TECHNICAL EVALUATION OF THE ADEQUACY OF
STATION ELECTRIC DISTRIBUTION SYSTEM VOLTAGES
FOR THE SAN ONOFRE NUCLEAR GENERATING STATION,
UNIT 1

James C. Selan
(Docket No. 50-206)

January 14, 1982

FIGURE 1. SAN ONOFRE NUCLEAR GENERATING STATION, UNIT 1 ELECTRICAL ONE-LINE DIAGRAM

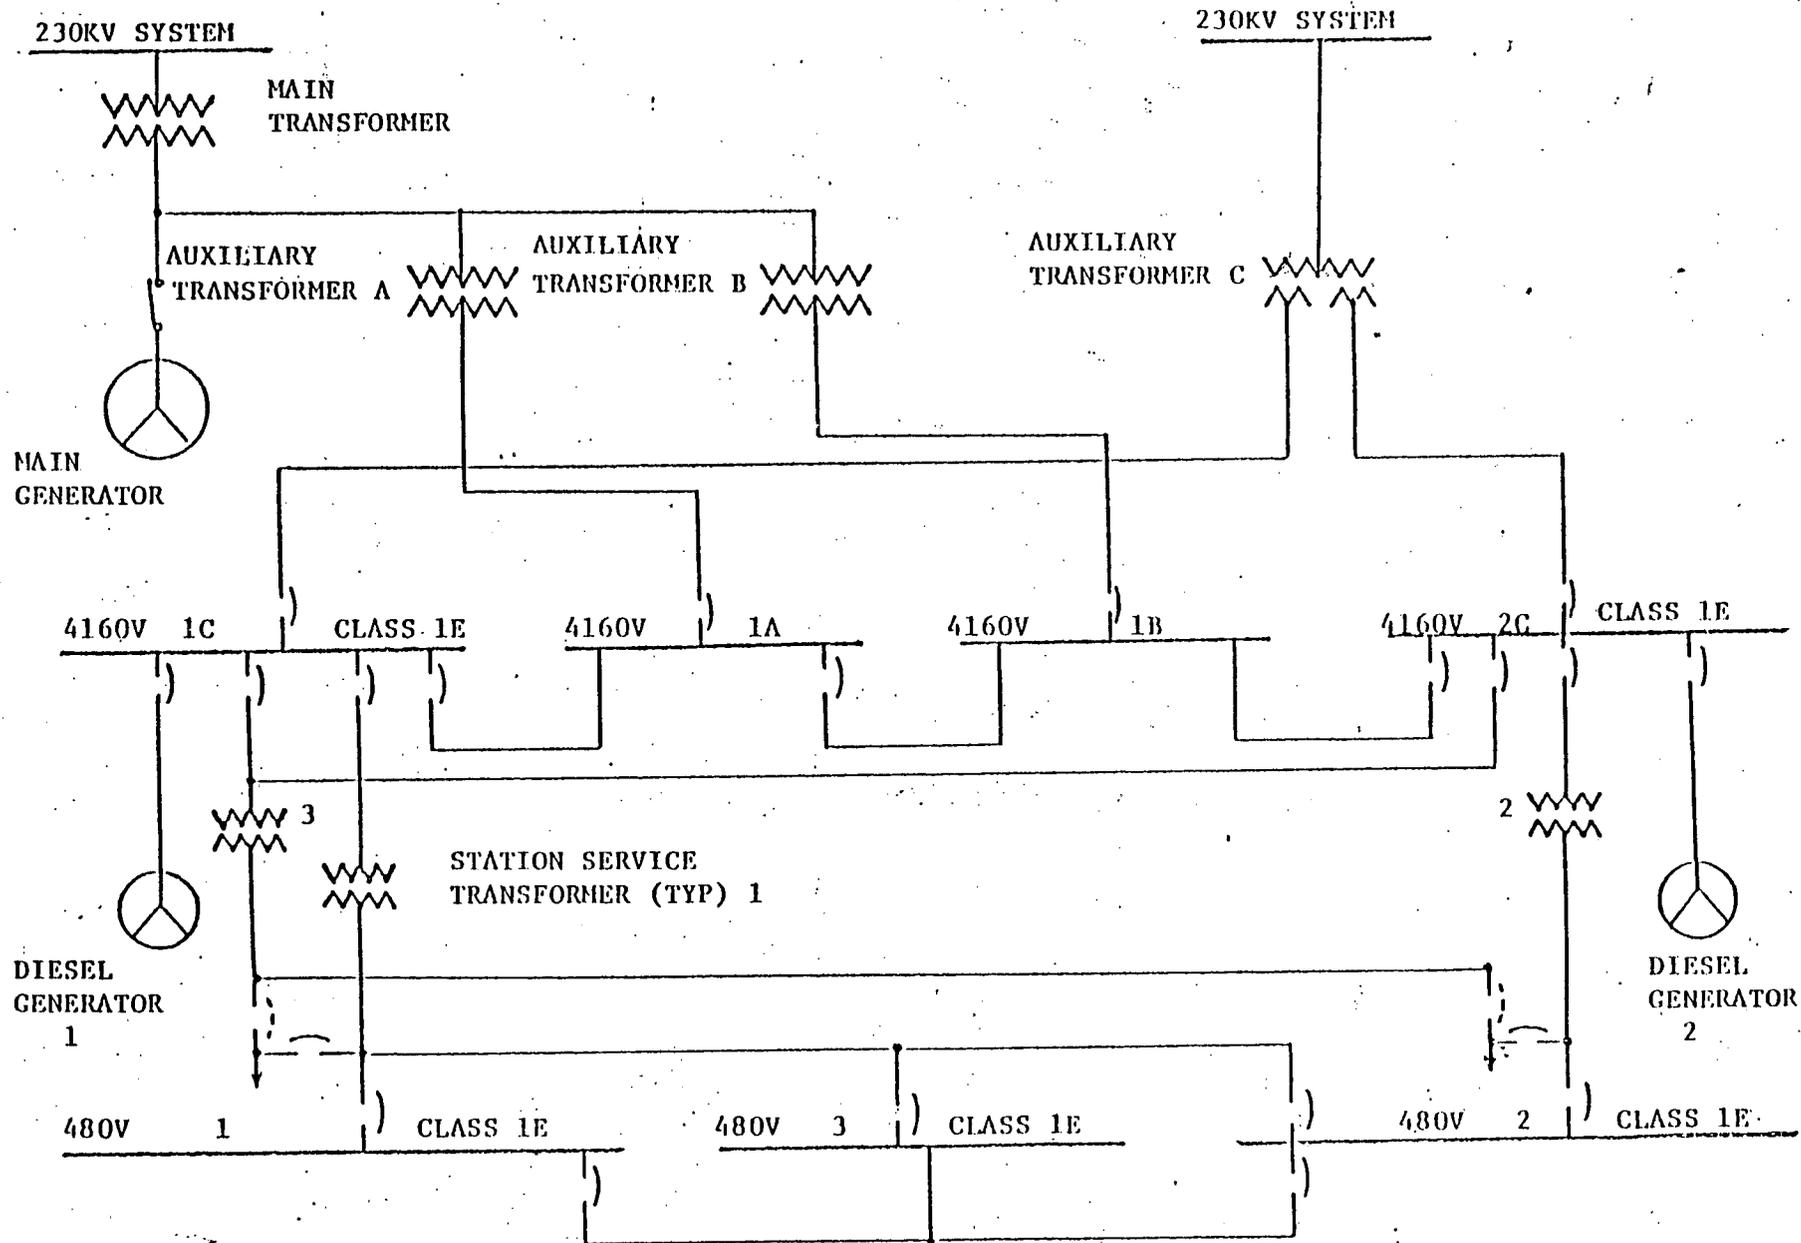
The voltage analysis submitted by SCE shows that the 440-volt Class 1E motor's upper voltage rating is exceeded by 2%. This 2% overvoltage is considered not to significantly affect the continued operation of the motors. The overvoltage condition can be eliminated by the adding of additional loads.
